Voyage Property Limited, Rev. Date Drwn Details of Issue / Revision Permitted and Proposed Elevations 1 - Apartment -  $\mbox{Do}$  not scale from this drawing. Use figured dimensions in all cases. - Verify dimensions on site and report any discrepancies to the Architect P2(S-1) FEB 2025 CO Issued for Planning Ashbourne Hall, immediately. reddy architecture +urbanism Dock Road, This drawing to be read in conjunction with the Architect's Specification. - © This drawing is copyright and may only be reproduced with the Architect's Limerick. Job No. Sheet Size: Scale @A1: WT3 WT5 1:200 Α1 P20-133D Wall Type 5 -Drawing Notes: Wall Type 3-Reviewed By: Issue Date: Drawn By: Painted render nap finish Selected buff brick with grey Refer to windows, doors and curtain walling schedules for more information on details and types. Refer to all other referenced architectural FEB 2025 RQ drawings for more information. Project Details: Purpose of Issue Dartry Mills, T: +353 (0)1 498 7000 Refer also to all other consultants drawings, specifications, reports and Dartry Road Greenpark Apartments - Blocks A & B Planning Application schedules including: Walsh Goodfellow for structural and civils, Renais

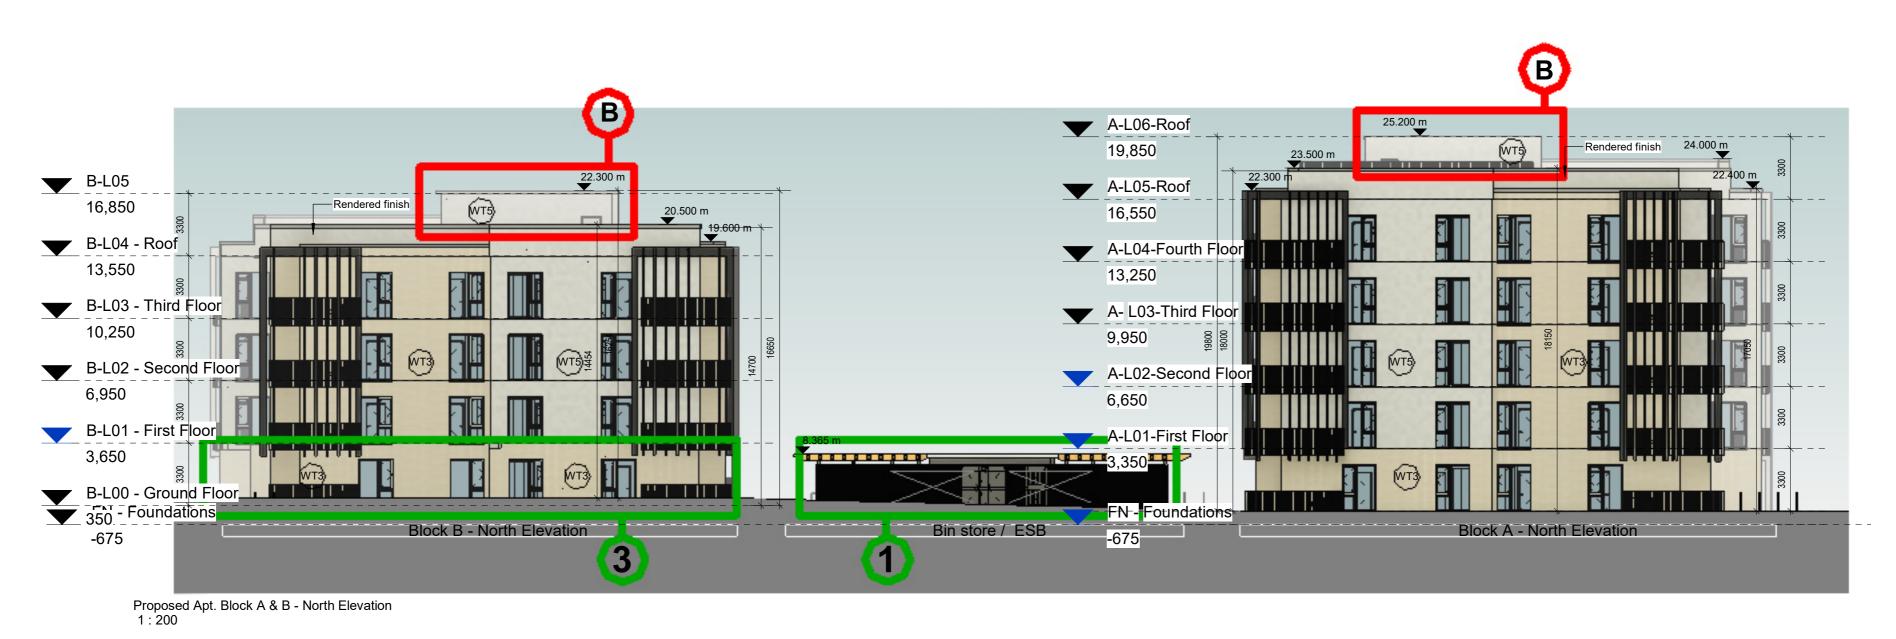
ESB Sub-Station, Switch
Room & Two Separate Bin
Enclosures in place of Two
Bike Store and a Bin Store.
 Bike Stores Relocated
Internally in place of

Redundant Plantrooms.
3. Two Amenity Rooms Replaced with Two 2-Bedroom UD Apartments & Cleaners Store.

A. Site layout changes: Sheffield stands modified or proposed.
Number, area and dimensions are specified in the floor plan.
B. Wall finish changed from Black Brick to Rendered finish as specified in the elevation drawings.
C. Cycle stands to be removed.
